County of Fairfax, Virginia

STAFF REPORT ADDENDUM

APPLICATION SE 2008-HM-010

APPLICANT: George B. and Carolyn L.E. Sagatov

Subdivision Exhibit

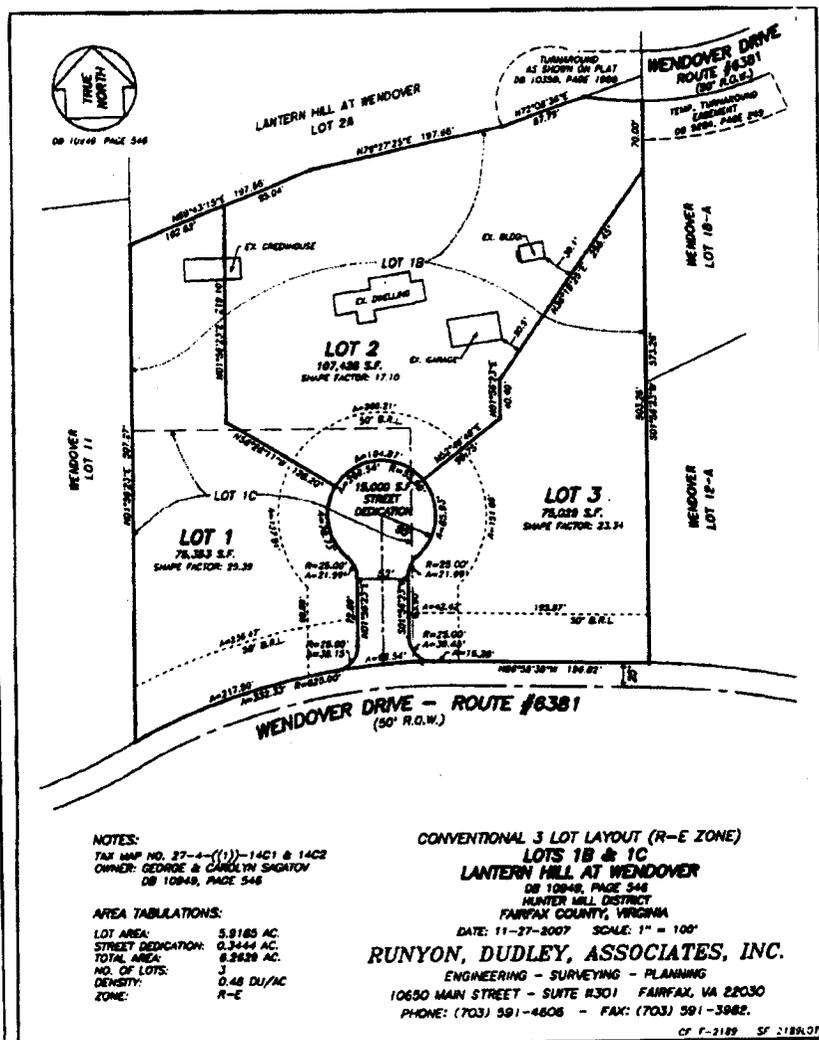
The applicants own the adjacent lot to the west (Parcel 14C2); however, this parcel is not included in the SE application. The applicants noted that they could subdivide Parcels 14C1 and 14C2 into three lots by-right by constructing a public street (cul-de-sac) off of the southerly portion of Wendover Drive, which would cross over

the EQC and provide access to the three lots (see following exhibit). The originally-submitted statement of justification declared:

This statement lead staff to believe that the applicants did not wish to develop Parcel 14C2. However, on December 3, 2009, after publication of the staff report, a revised statement of justification was submitted by the applicants clarifying that it was never their intention to leave this parcel vacant, but to develop it at some time in the future. The statement has been revised to state the following:

Their preference would be to subdivide Parcel 14C1 into two lots as shown on the special exception plat and to develop Parcel 14C2 as it is currently configured.

SPECIAL EXCEPTION PLAT
ONSITE/OFFSITE DRAINAGE DIVIDES & CHARTS
LOT 18
LANTERN HILL AT WENDOVER
FAIRFAX COUNTY, VIRGINIA

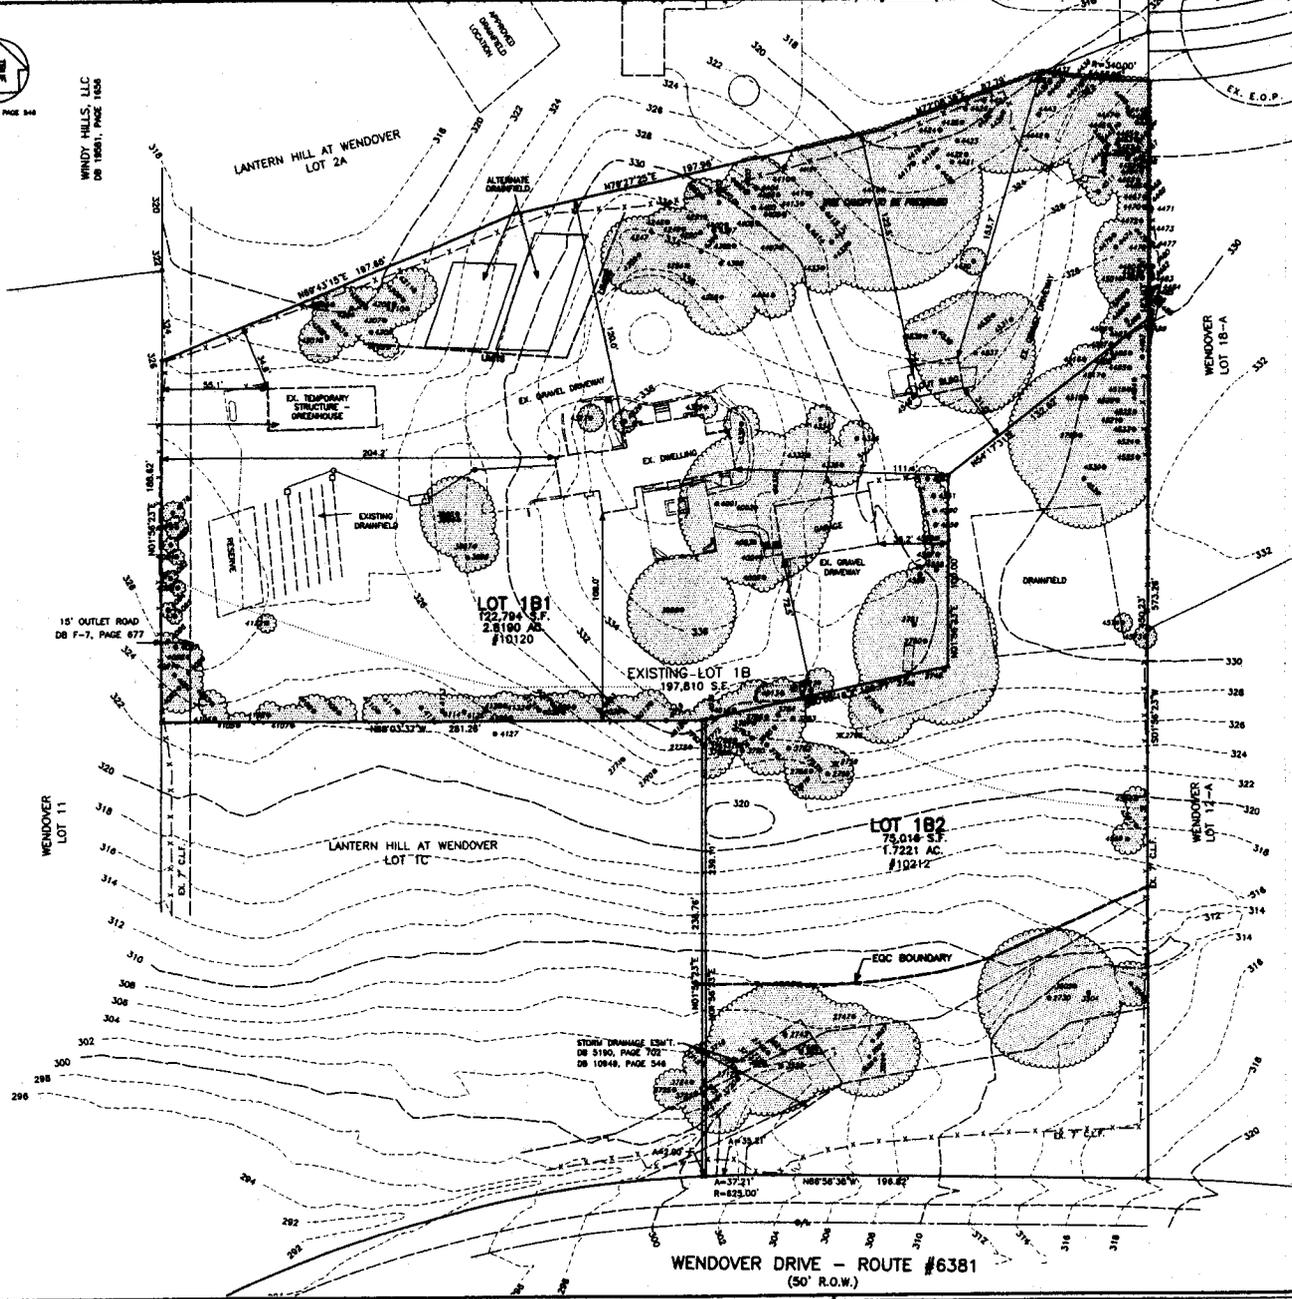
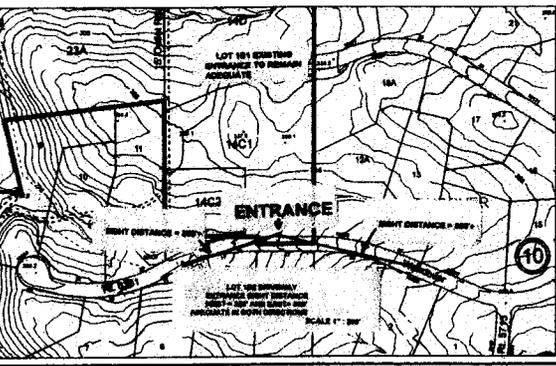
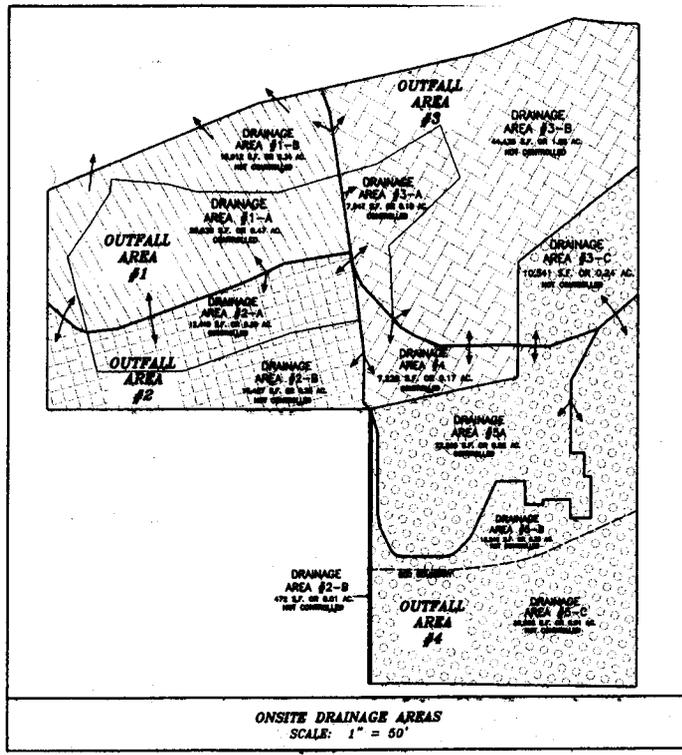
DPWES staff advised the applicants that proposed Infiltration Trench #1 appeared to be too close to an approved alternate drainfield and proposed Infiltration Trench # 2 appeared to be too close to the existing drainfield and a reserve drainfield. Staff also advised the applicants that a bioretention basin could be used instead of the proposed bioretention filter on proposed Lot 1B2, so that the applicants would not have to apply for a full stormwater detention waiver. A note was added to the SE Plat which stated that infiltration would be used in the bioretention facility if possible, to avoid construction of an outlet pipe in the EQC.

Finally, staff noted that the SE Plat included land use credits in the BMP calculations which are not allowed on lots with single-family detached dwellings.

Once these credits are taken out of the BMP calculations, it appeared to staff that a partial BMP waiver would be required.

On November 20, 2009, a revised SE Plat was submitted. The applicant is now proposing to construct four bio-retention basins instead of the three infiltration trenches and the bio-retention filter. The bio-retention basins replacing Infiltration Trenches #1 and #2 have been moved further away from the affected drainfields. Additionally, the applicant is now proposing to extend a shorter pipe from the bio-retention basin that is replacing the bio-retention filter on proposed Lot 1B2; however, the pipe is still encroaching into the EQC. It would be staff's desire that there be no encroachment into the EQC at all.

The SE Plat has also been revised to depict several proposed WQMAS (Water Quality Management Areas) on-site and a note has also been added requesting a partial waiver of the structural Best Management Practices (BMP) requirements due to the inclusion of these WQMAS.
